[EPA–R08–OAR–2018–0606; FRL–9992–73–
Region 8]

Approval and Promulgation of Air Quality Implementation Plans; Wyoming; Revisions to Regional Haze State Implementation Plan; Revisions to Regional Haze Federal Implementation Plan

ACTION: Final rule.

Figure 1. Map Depicting Federal Class I Areas and Representative IMPROVE Monitors in Wyoming.

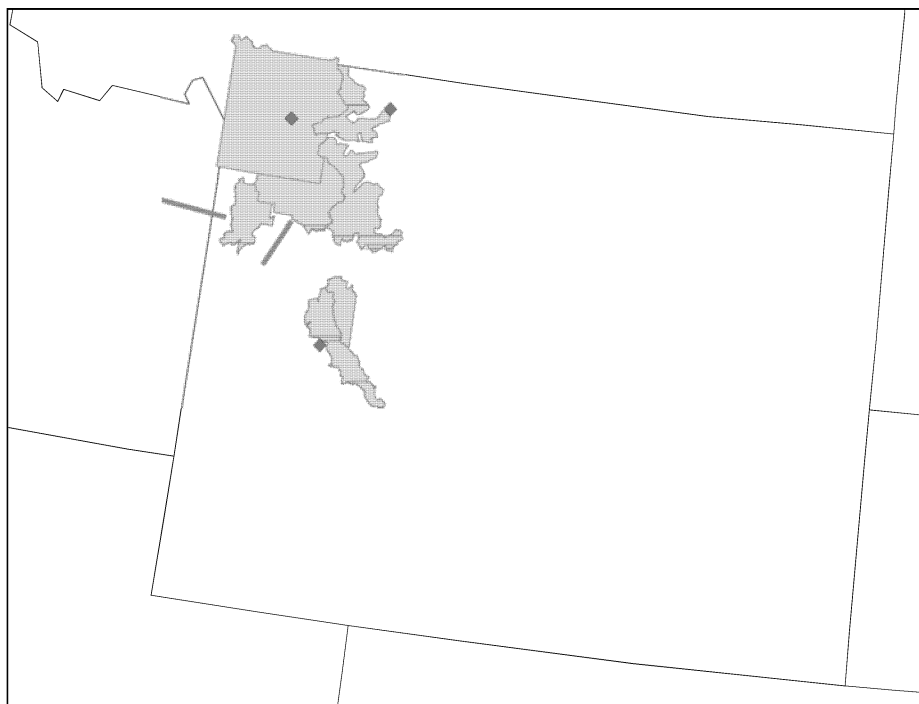
Comment: Finally, the commenters argue that multiple features of the EPA’s modeling exacerbate the uncertainty inherent in CAMx and compound the unreliability of the results on which the EPA relies upon in its BART alternative determination, including:⁹⁸

Response: We disagree with the commenters’ arguments that multiple features of our modeling, including large transport distances, lack of IMPROVE monitors, and the use of PSAT exacerbated the uncertainty inherent in CAMx and compounded the unreliability of the results on which we relied upon in our BART alternative determination. In fact, we utilized multiple tools, as discussed previously, to further evaluate the modeling results to determine whether the results represent “real” modeled visibility differences.

Specifically, it is true that in some geographic areas, single IMPROVE monitors represent multiple Class I areas, based on expected similarities between the airsheds (Figure 1). This
